Calvert Cliffs Nuclear Power Plant

Unit Nos. 1 & 2; Docket Nos. 50-317 & 50-318

Responses to Request for Additional Information for the Review of the Calvert Cliffs Nuclear Power Plant, Units 1 & 2, Integrated Plant Assessment Report for the Compressed Air System

The following simplified diagram of the CAS is a presentation of the SR/NSR boundaries for Unit 1. Unit 2 is similar.

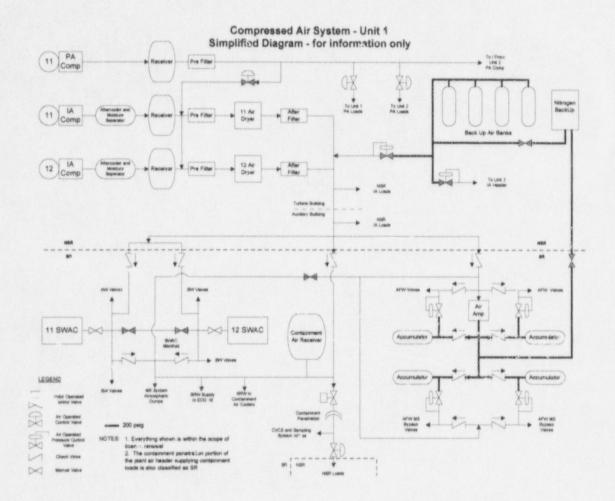
A simplified diagram of the Compressed Air System (CAS), Section 5.4 of the Baltimore Gas and Electric Company (BGE) License Renewal Application (LRA), depicting the portions of the system that are within the scope of license renewal, as was included with other sections in the LRA that the staff has reviewed, was not provided. As a result, the staff is having difficulty gleaning from the CAS report exactly which portions of the CAS are or are not designated to be within the scope of license renewal. The information in the Updated Final Safety Analysis Report also did not help in this regard. Please provide a simplified diagram depicting the major portions of the system, consistent with the level of detail provided in other system diagrams provided in the LRA, and discuss in more detail exactly where there are any boundaries that separate license renewal non-scope and within-scope portions of the system. If a simplified diagram is not available, then another option would be to use the existing plant piping and instrument drawing or Updated Final Safety Analysis Report figures for the air systems, and supplement the drawings with a summary description of the boundaries of the CAS in sufficient detail such that the staff will be able to determine which components are within and outside of the scope of license renewal.

The next two Questions, Nos. 2 and 3, arose partly because a simplified diagram was not provided to aid the staff in its understanding of the license renewal boundaries of the CAS. In developing your response to Question No. 1, please consider the following questions, in part, as additional guidance related to the level of detail to include, in order to facilitate the staff's understanding of your responses to these questions.

The CAS report indicates that all components of the CAS that support the system functions, with the exception of the fire protection function, are SR and seismic Category I. Please provide clarification between the SR and NSR interfaces within the CAS to assist the staff with determining which interfaces within the CAS are within and outside the scope of license renewal.

air loads throughout the plant during normal operation. A SR backup supply is provided by the Saltwater Air Subsystem from a set of redundant air compressors. As shown on the attached simplified drawing, the pressure boundary of the SR portions of the CAS is isolated from the pressure boundary of the NSR portions of the system by check valves, control valves, and manual valves.
